Re: Petition 1574– Interrogatory

Response to CSC-01 Interrogatories dated July 13, 2023
CSC-Petition 1574 Interrogatory responses

The Southington Substation to Cook Hill Junction Rebuild Project (the Project) was not identified by an ISO-New England Inc. needs and solution analysis. The Project is associated with the Asset Condition List (Project numbers 362 and 363) as well as Eversource's Local System Plan (Project reported as "115-kV Line 1690 Copper Retirement").

Question: 34

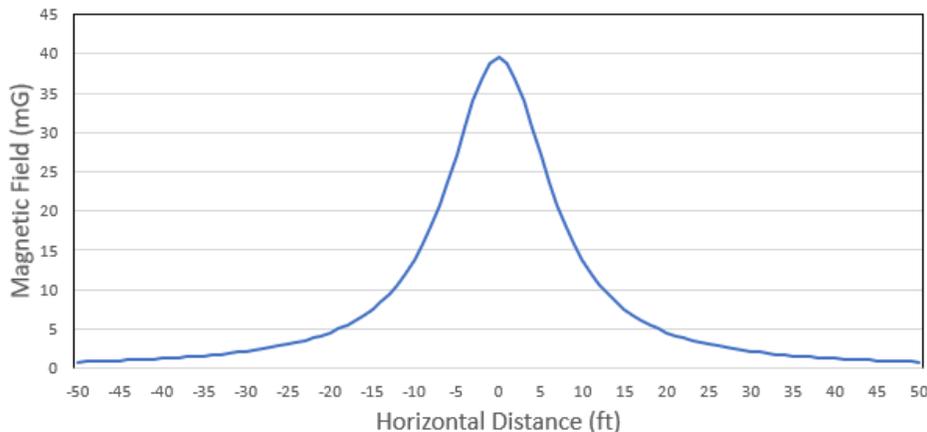
Referencing Petition pp. 30-32, electric and magnetic field (EMF) tables are included for the Project. Is the underground transmission segment at Lucchini Junction taken into account in the EMF tables? If no, would it be expected to materially impact EMF at the ROW edges
